## Certificate of Appropriateness

North Point South HD 2251 N. Lake Dr.

Date issued 10/8/2019 PTS ID 114596 COA masonry repairs

Front (East) elevation of the property

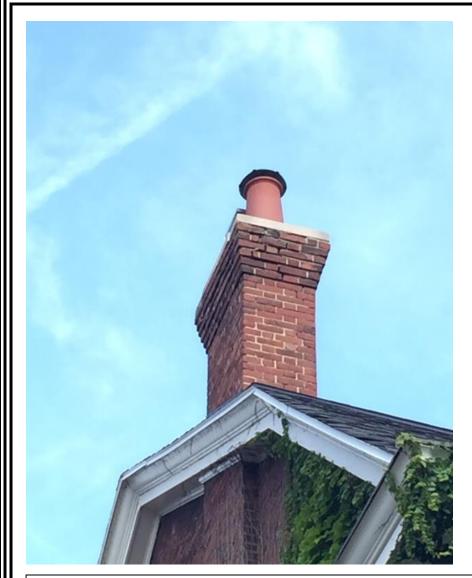
The (partially) rebuilt chimney must be rebuilt to exactly match the historic including bonding pattern, corbeling, and other details. Accurate measurements shall be taken prior to disassembling so the new chimney exactly matches the historic without alteration.

South chimney (Left) will be tuck pointed, damaged brick will be removed, and brick in good condition will be utilized at the rear (southwest) corner of the home for infill. The chimney will be reconstructed with brick and mortar that matches the existing condition. The chimney will retain its profile and corbeling.

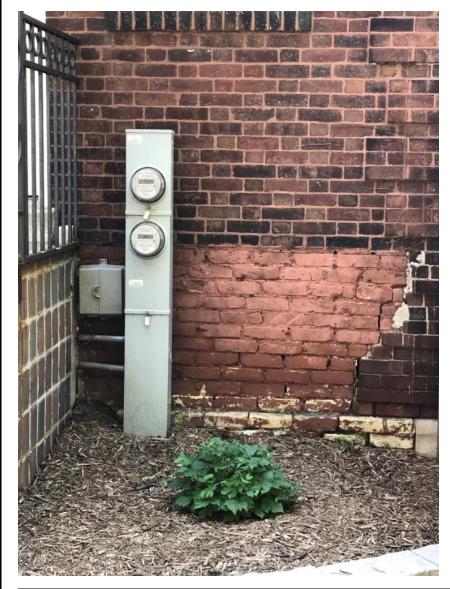
Images of southwest corner of the home. Brick infill will be removed. Right image include samples of brick and mortar to be utilized for new infill. Some bricks removed from the chimney will be mixed throughout the infill at the southwest corner. The new infill will match the existing Flemish bond utilized on the home. Mortar and brick sampled approved on-site 09-24-19.

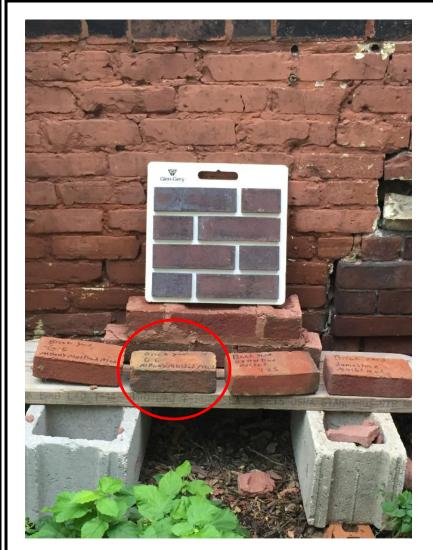
Detail images of (Left) the mortar sample, coursing sample (indicating Flemish bond) and (Right) brick to be utilized for infill at this location and for the reconstruction of the southern chimney
